Figure 1: Entry Landscape Treatment, LVEA July 2023

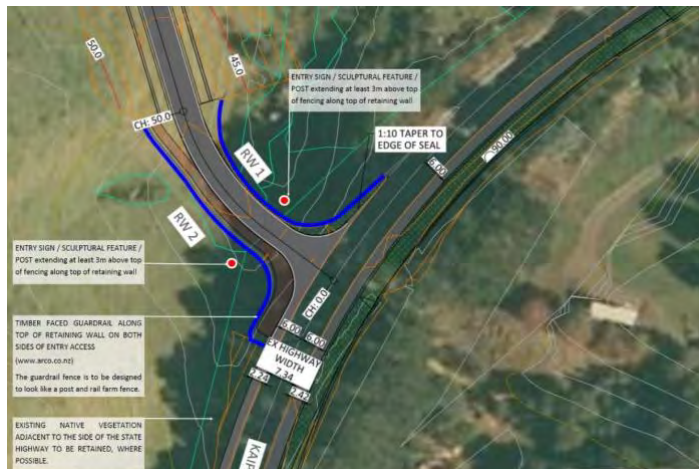
1.9 Please provide details of the proposed signage.

The signage is yet to be designed. It is envisaged that two posts extending 3m above the top of the fencing along the retaining wall on either side of the site access are to be used for either signage into the property or a sculpture. These posts will be in amongst the riparian vegetation adjacent to the stream. These will be designed around the following parameters:

- in the form of a large post on either side of the entry
- to be used for either entry signage, or for sculptural purposes (e.g. a carved post, or to support a sculptural element)
- limited to extending a maximum of 3.5m above the top of the fencing along the top of the retaining wall
- carved posts to be designed in keeping with the overall nature and character of the proposal which is a working farm located in this relatively rugged and wild coastal location on the edge of the Kaipara Harbour.

Figure 2: Highly Productive Land Classification with Proposed Scheme Overlay, Soil and Resource Report for 2127 Kaipara Coast Highway, January 2024

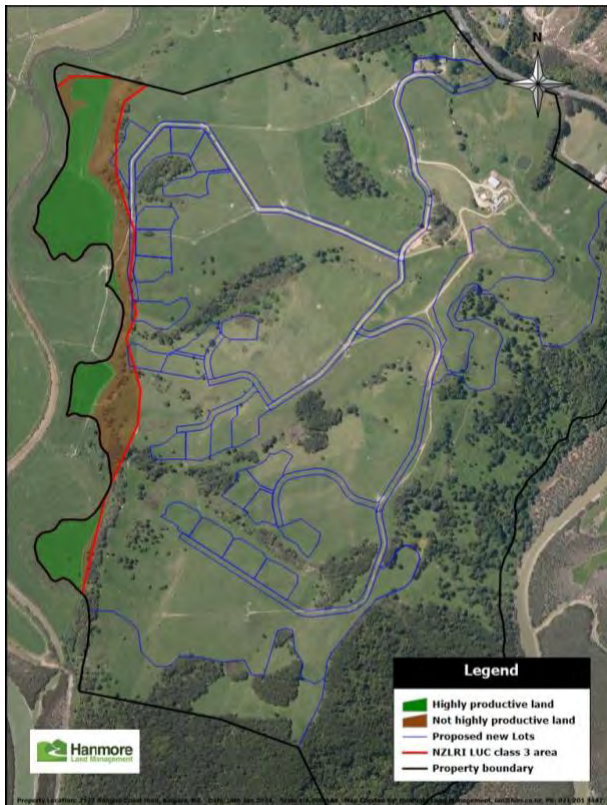
1.12 As noted in previous correspondence and the AEE, the western extent of the site is indicated as containing Highly Productive Land and the National Policy Statement on Highly Productive Land is relevant. While assessment in the AEE is noted, please provide a detailed analysis in the context of the NPS- HPL, having regard to the language used in this document (such as “avoid”) and the limited exclusions present.

As such, these productive land areas are proposed to be protected from development, noted as Da, L and N on the Management and Maintenance Planting Plan, refer Attachment 5. The land around this area is reclaimed and it is proposed for these three areas to be regenerated with native grassland species. The productive nature of the soils will not be developed upon. As the proposal “provides for the retirement of land from land-based primary production for the purpose of improving water quality” then that use is consistent with NPS:HPL clause 3.9(2)(f). Based on this, it is considered that the proposal is not contrary to clause 3.8 NPS-HPL in terms of s104D.

SEA and SEA quality vegetation map

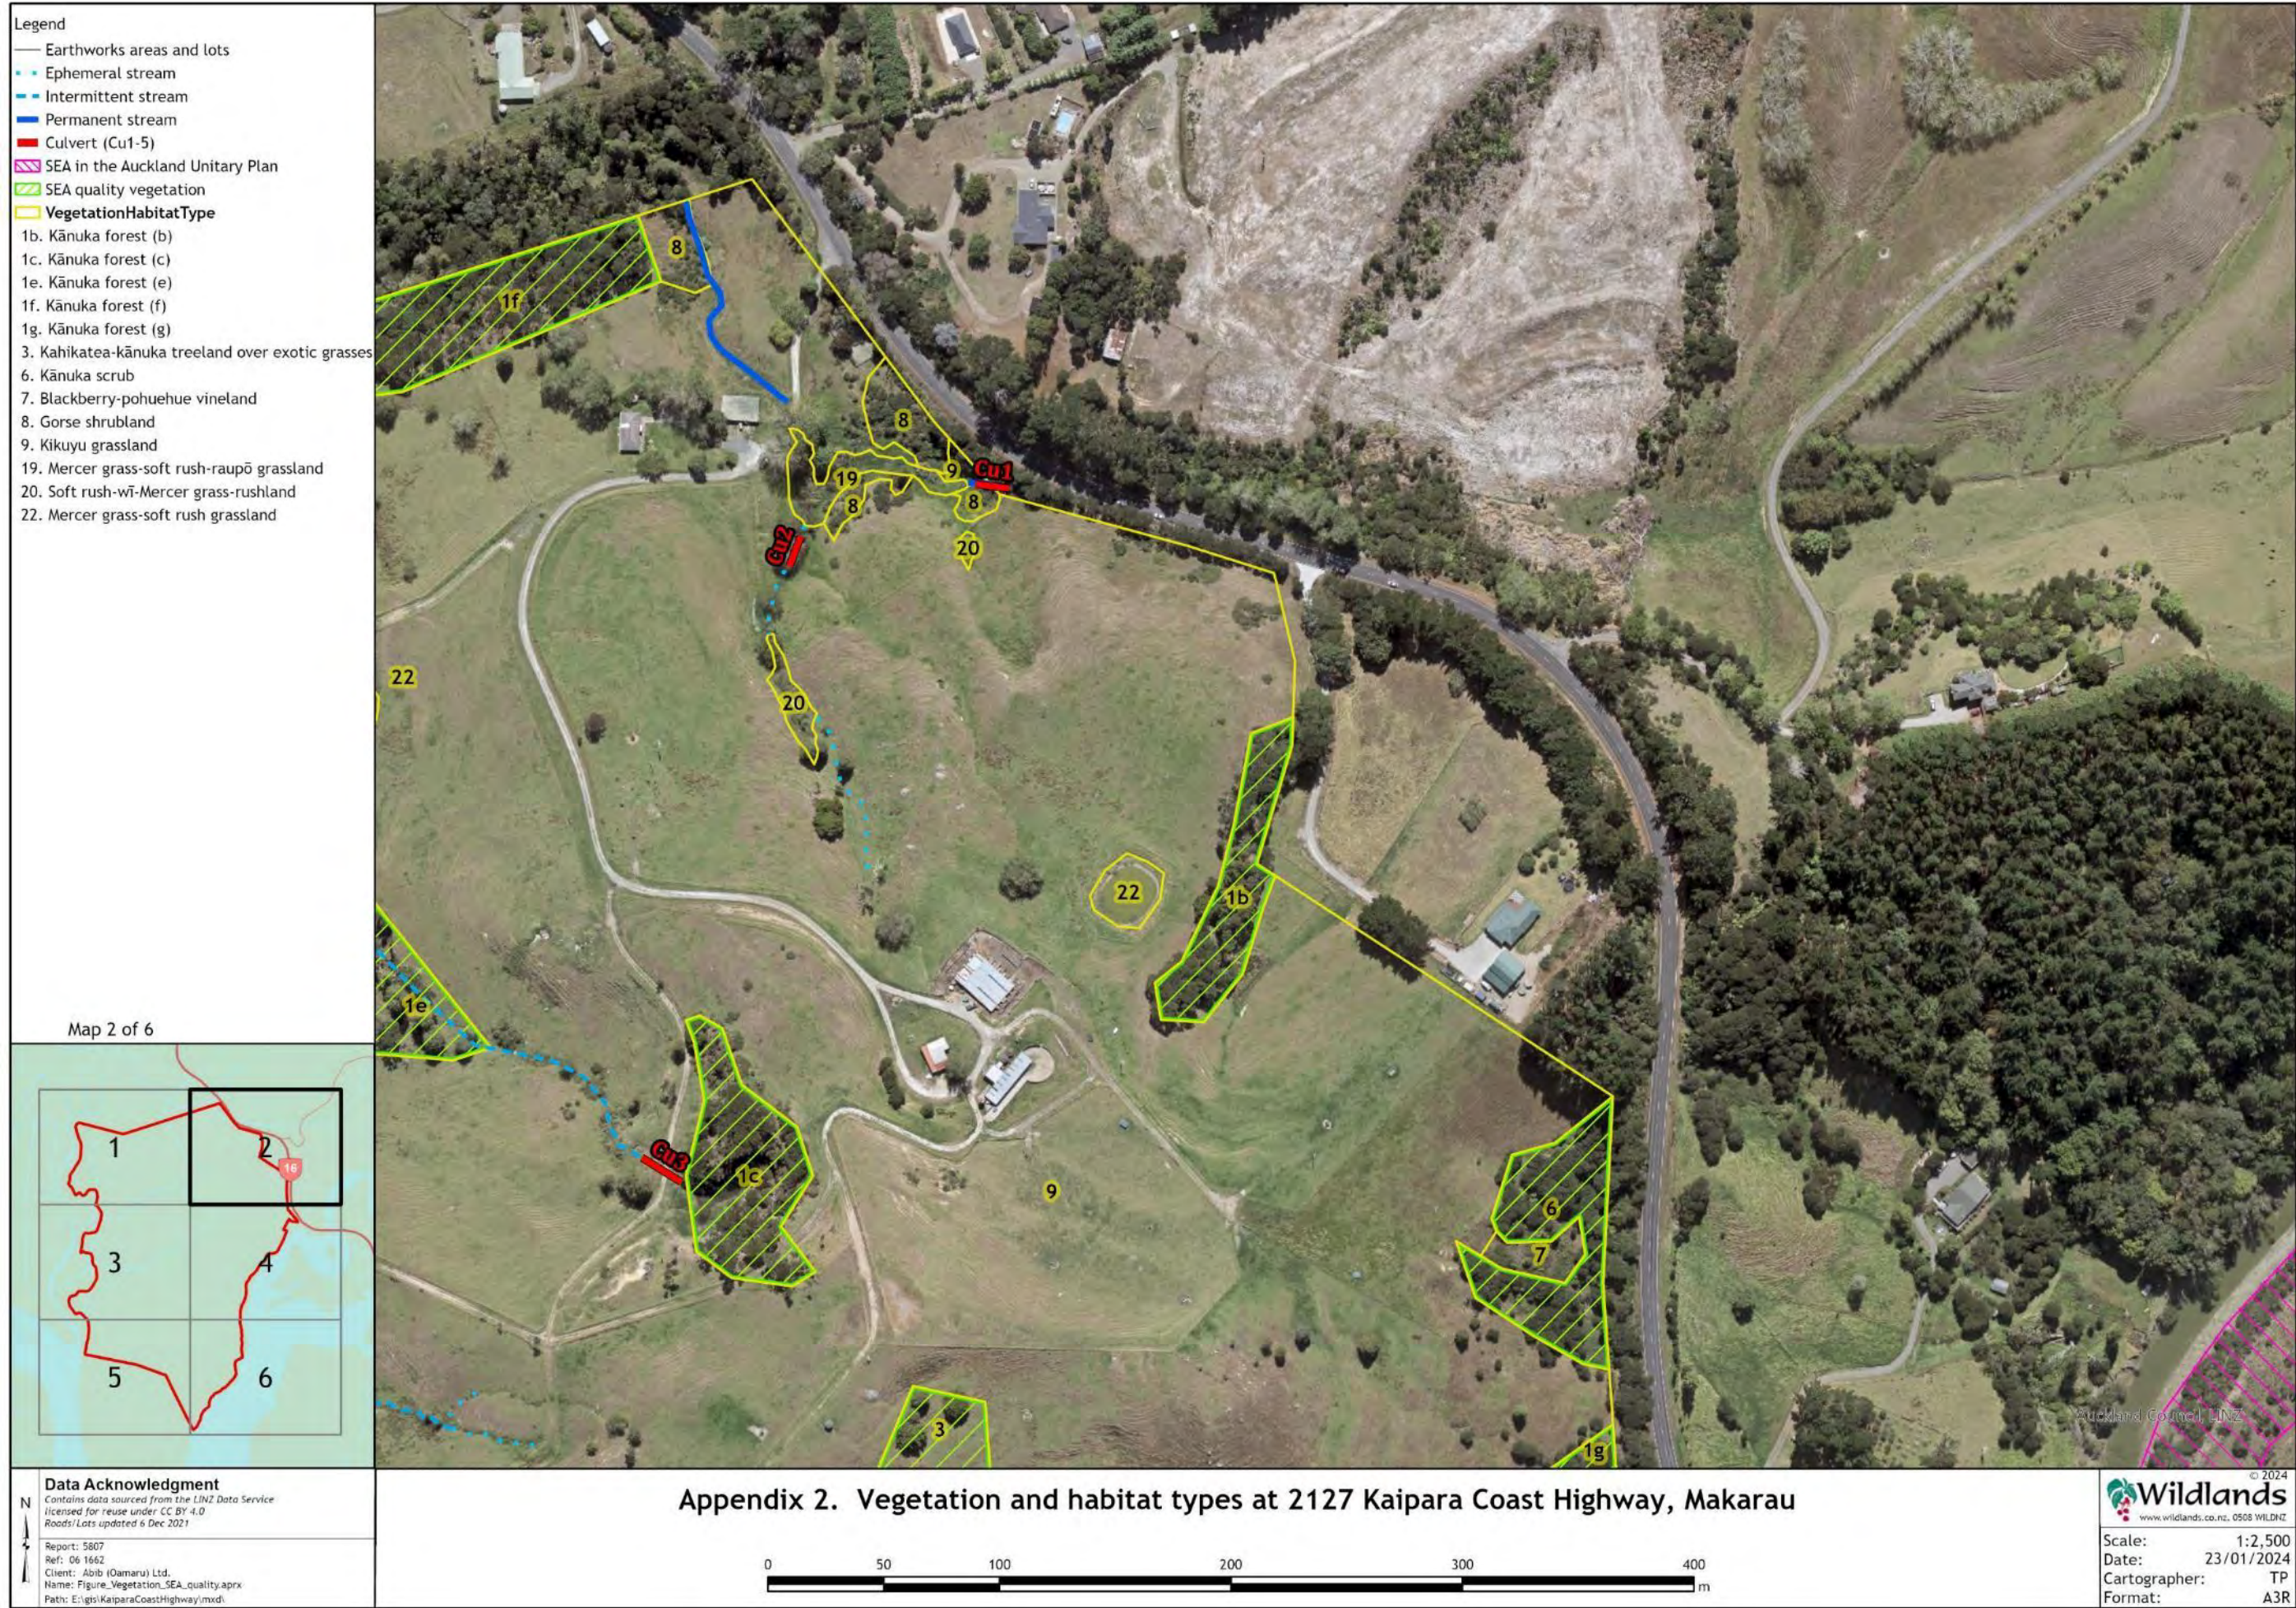
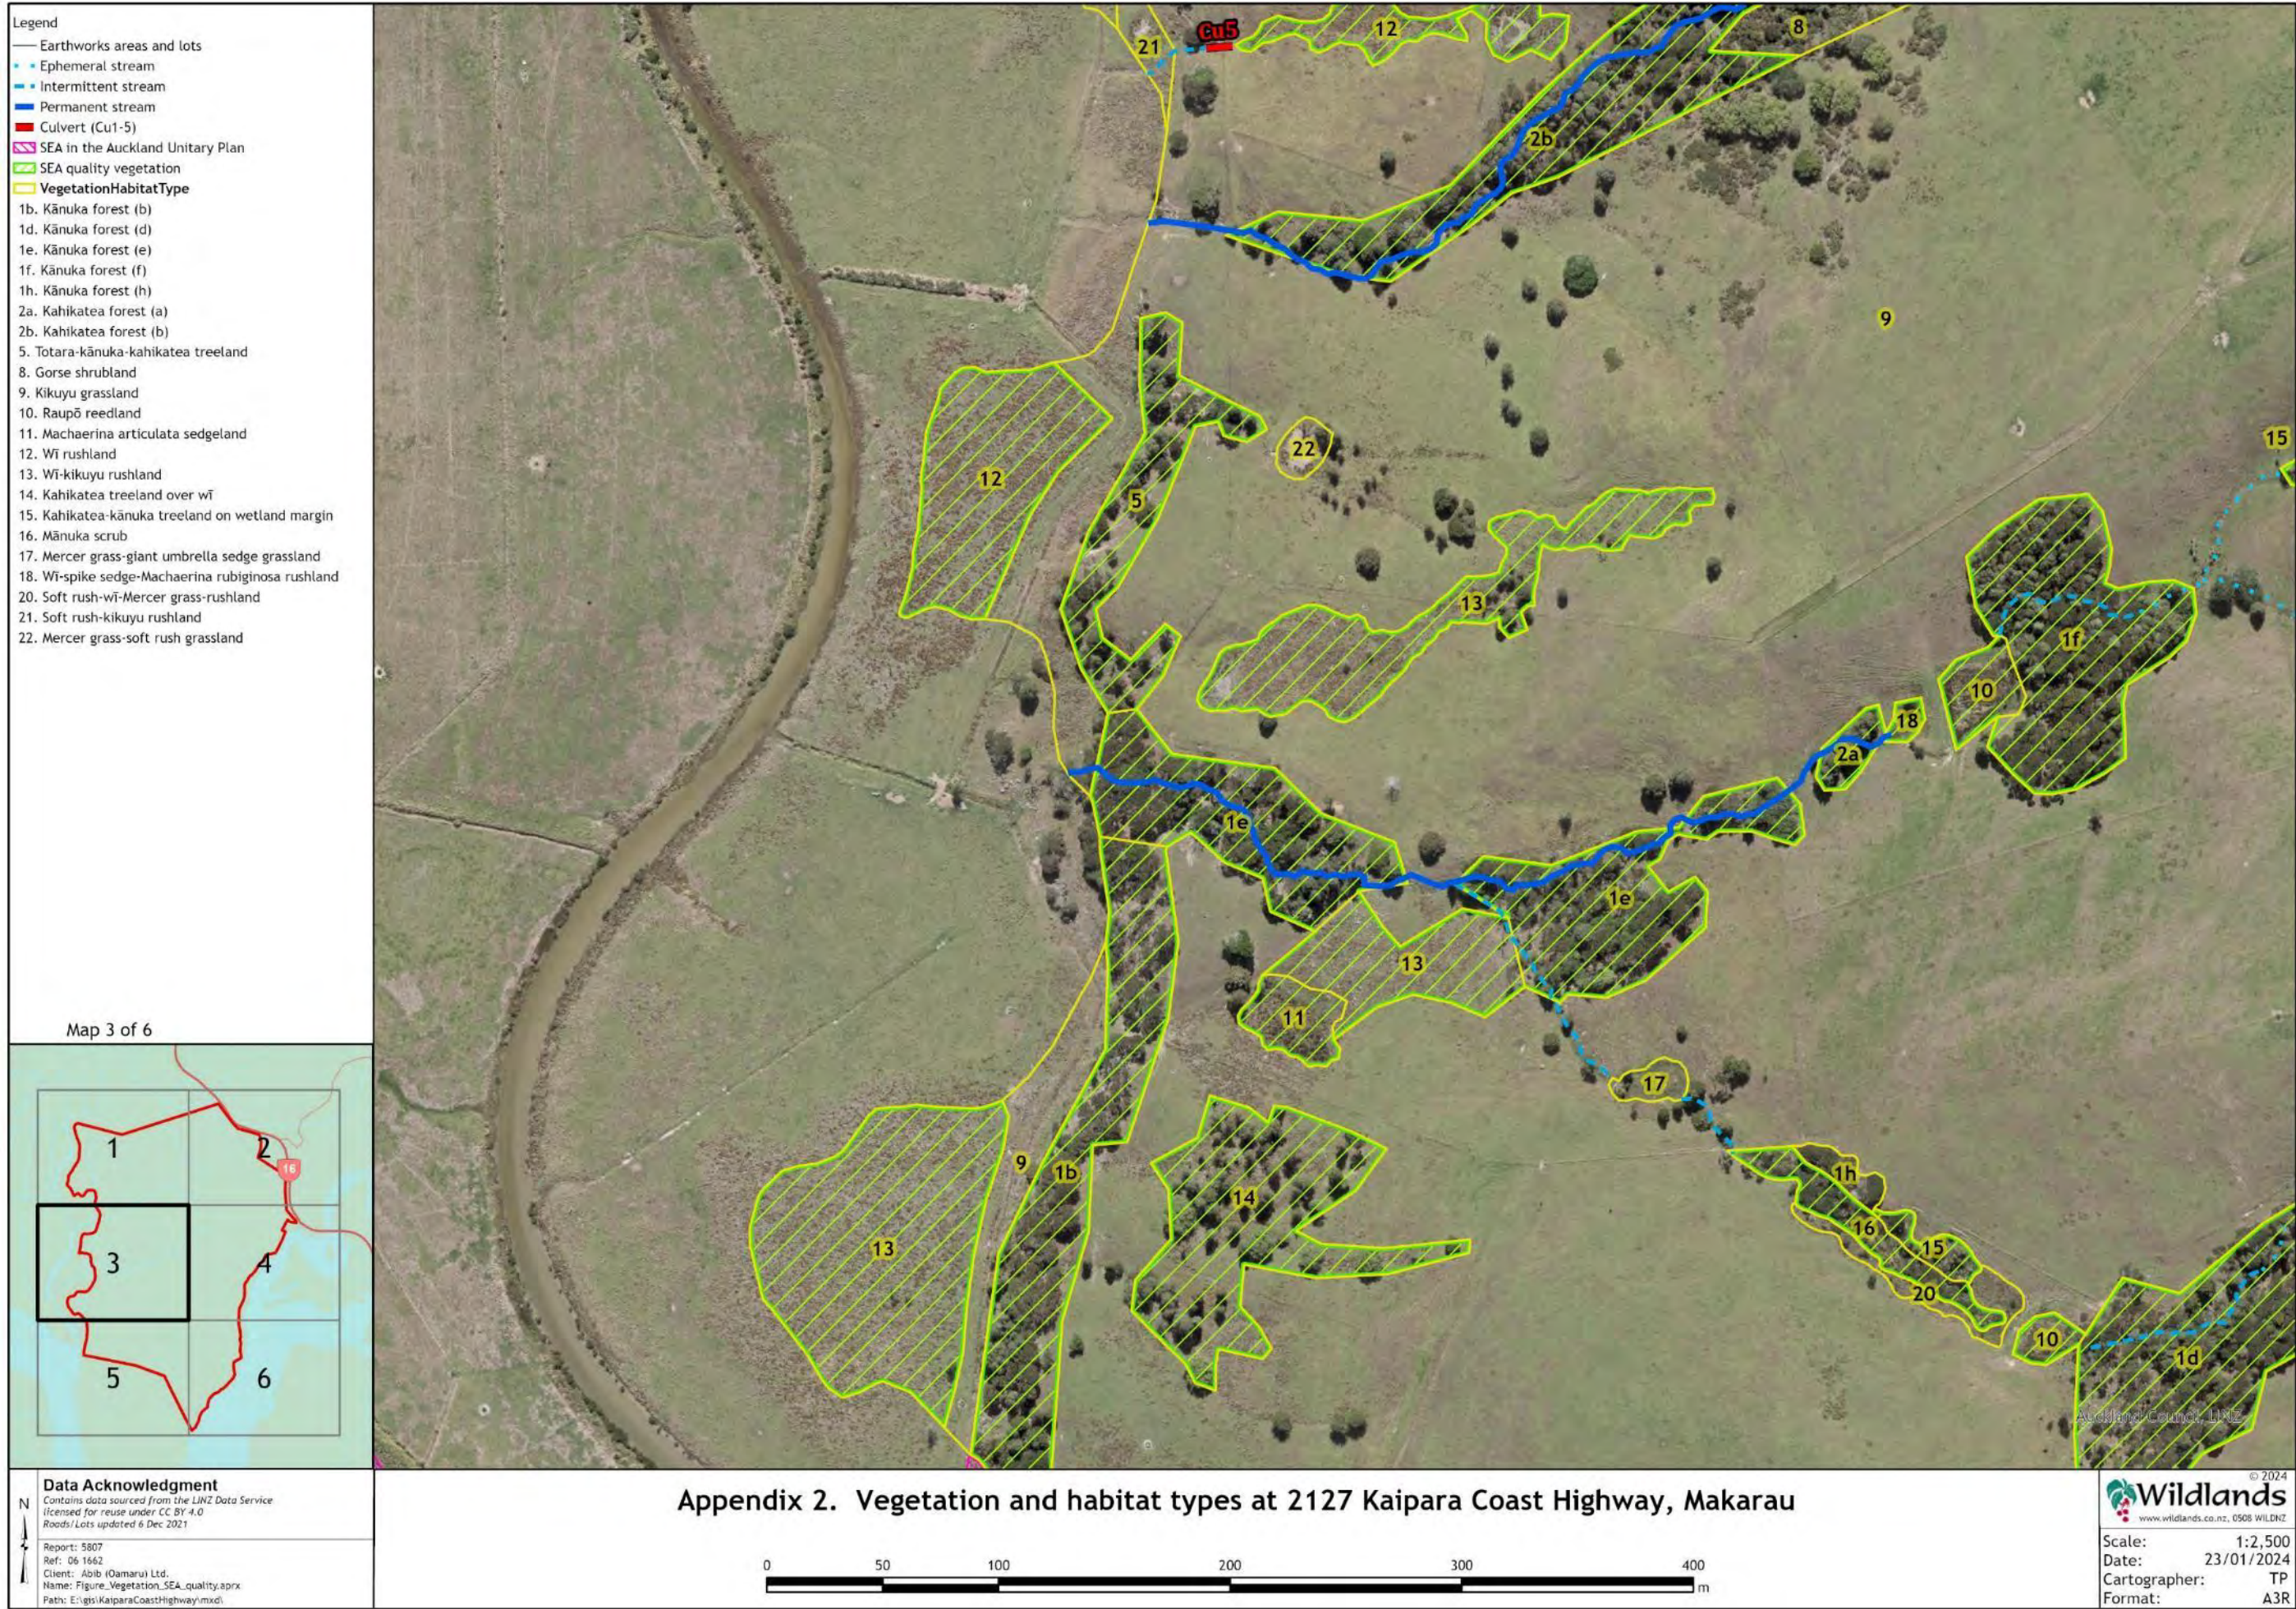
- 1.47 *A plan is requested as per E39.6.1.6 clearly identifying SEA areas and other areas of indigenous vegetation, wetlands, and watercourses on site.*

- 1.48 *Please provide an assessment of areas of vegetation proposed for protection that are already identified as SEA or areas meeting the factors for Significant Ecological Areas in Policy B7.2.2(1) and confirm the areas (m2) each of the areas within the site cover.*

“The maps provided in the original Ecological Impact Assessment (EclA) have been updated to include the SEA overlay and any areas that are of ‘SEA Quality’ (Appendix 2). As outlined in the EclA, this includes all areas of forest, treeland, and scrub at the site as they are likely to provide habitat for indigenous fauna species that have been classified as ‘Threatened’ or ‘At Risk’ (Factor 2b: Threat status and rarity). These fauna habitat values are discussed in more detail in Section 6 of the EclA. These vegetation types also form part of a network of sites that cumulatively provide important habitat for indigenous fauna (Factor 4c: Stepping-stones, migration pathways and buffers).

All natural inland wetland areas that are dominated by indigenous plant species also meet the criteria to be classified as SEA (Factor 2d: Threat status and rarity) and have therefore been mapped accordingly (Appendix 2).
